GEXL80 CORRELATION FOR SVEA96+ FUEL

NEDO-33107-A

SAFETY EVALUATION BY THE OFFICE OF NUCLEAR REACTOR REGULATION

LICENSING TOPICAL REPORT NEDC-33107P, "GEXL80 CORRELATION

Figure 2-1. SVEA96+ Assembly Rod Numbering System

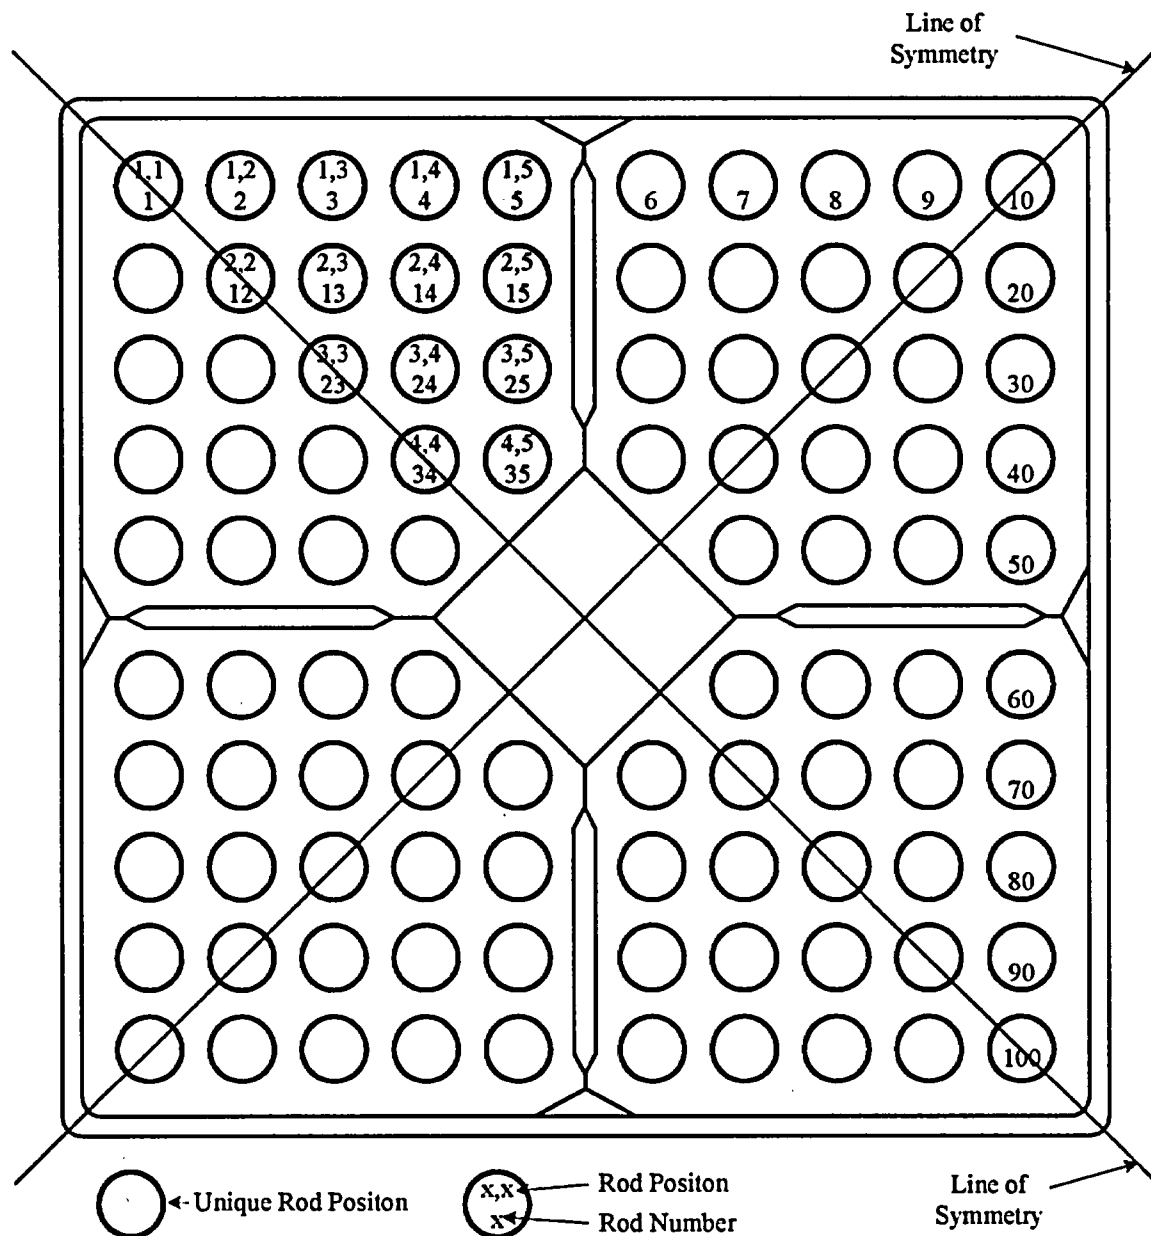
The SVEA96+ bundle is divided into four mini-bundles by the water cross as shown in Figure 2-1. The four mini-bundles are four parallel flow channels that all are subject to the same pressure drop. If the SVEA96+ bundle has a quadrant symmetric pin power distribution, the four mini-bundles have the same power and they will also have the same mass flux and critical power performance. If, on the other hand, the pin power distribution is not symmetric the four mini-bundles will have different powers. The mini-bundle with the highest power will have the highest vapor generation and, therefore, its two-phase pressure drop will increase relative to the other three mini-bundles. Since the four mini-bundles all have the same pressure drop, the impact of the higher two-phase pressure drop in the hottest bundle must be offset by a reduced inlet flow and a corresponding lower single phase pressure drop. Similarly the mini-bundle with the lowest power will have less vapor generation, less two-phase pressure drop and correspondingly must have a higher inlet flow and higher single phase pressure drop. Therefore the impact of a power mis-match between the four mini-bundles in the SVEA96+ fuel bundle is that the mini-bundle with the highest power has a mass flux that is less than the average for the bundle, and the mini-bundle with the lowest power has a mass flux that is higher than the average. For a mini-bundle a reduction in the mass flux will produce a corresponding reduction in the mini-bundle critical power (critical power is a monotonically increasing function with mass flux).

**Figure A-3. Identification of Rods in Positions Adjacent to Rod i**

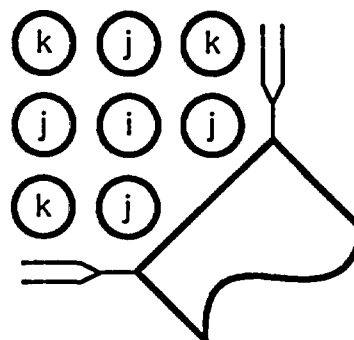
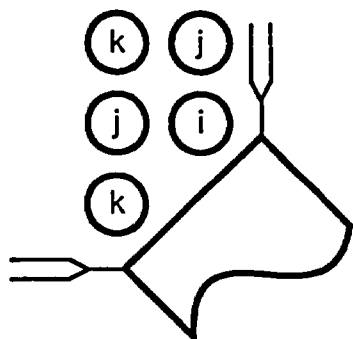
6. On pages A-9 to A-10, three figures are briefly discussed. Please be prepared to discuss these same figures in detail.

These figures address the 'mini-bundle variation term.' See response to Question 2 above.
